Detroit
Edison

Subject: Semi-Annual Radiological Effluent Release Report

DETROIT EDISON COMPANY
FERMI 2 NUCLEAR POWER PLANT
OPERATING LICENSE NO. NPF. - 43

SEMIANNUAL RADIOACTIVE EFFLUENT RELEASE REPORT

Appvl RWR
Date 12/1/90

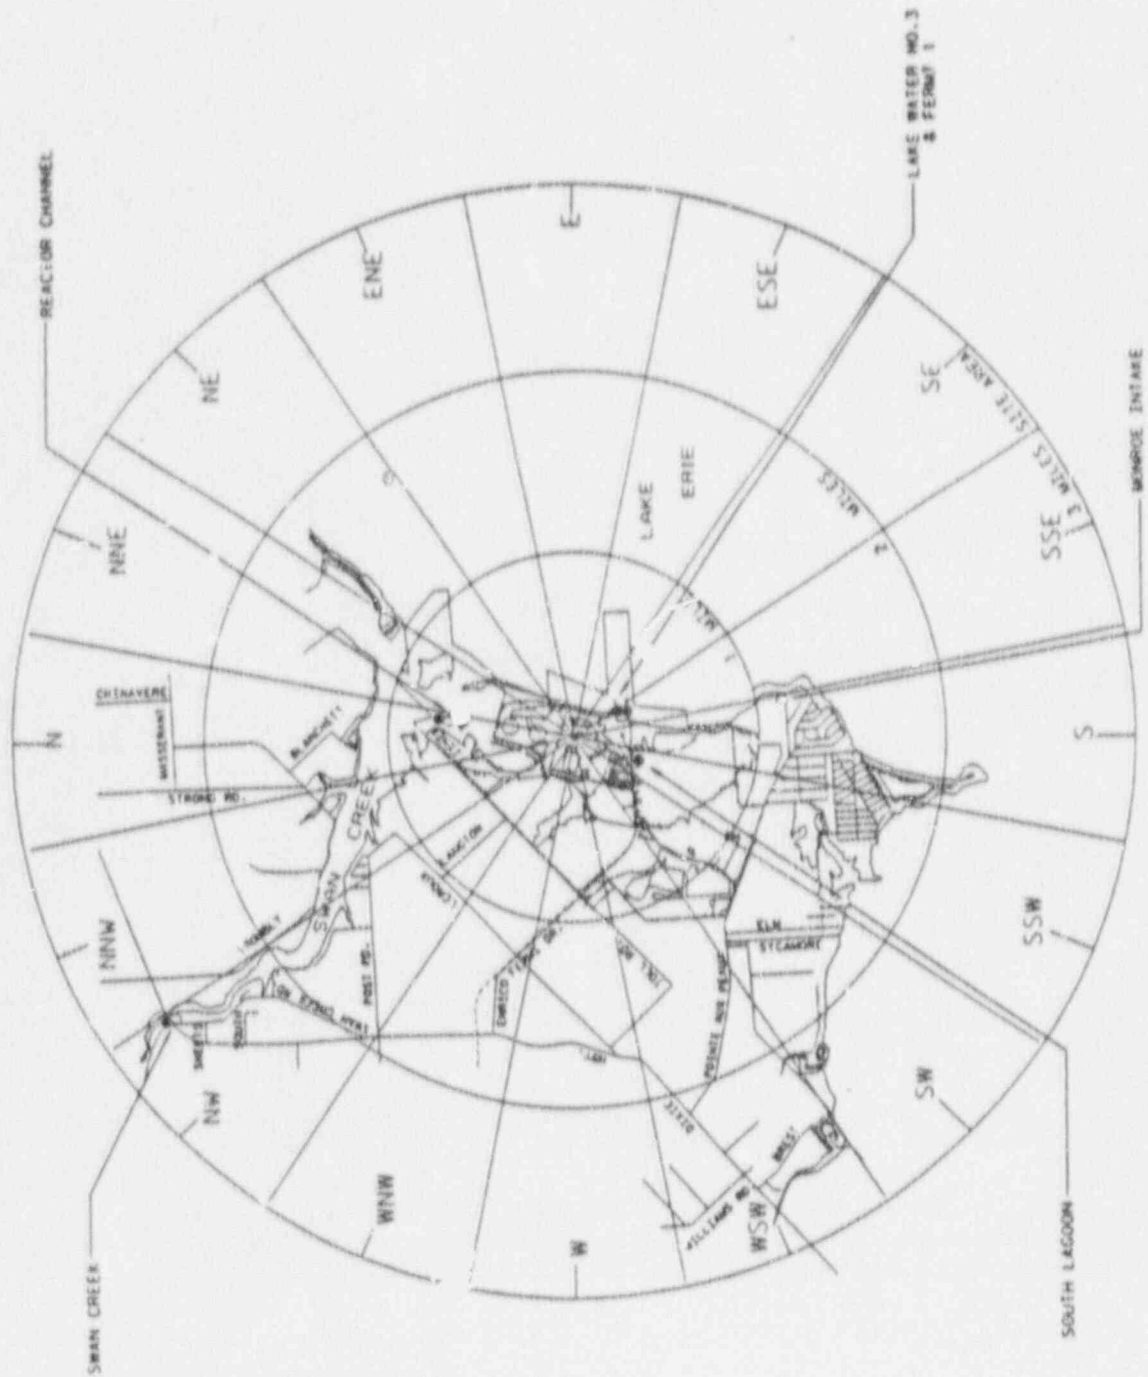
Section/Page	Change	Basis
		census activity.
		Additionally, per the
		bases of T.S. 3/4.12.2,
		the land use census is
		for areas at and beyond
		site boundary, so it is
		not meant to cover areas
		within the boundary
		anyway.
6.0-8,11,12	Update and correct REMP	Sampling locations
	tables based on current	change because of land
	sampling locations and	use census data partici-
	new distance calculations	pation by the public in
	and latest land use census	the REMP, critical
		receptor analysis, and
		distance recalculation
		by DECo cartographers.
6.0-15 through 19	Improve readability of	N/A.
	maps.
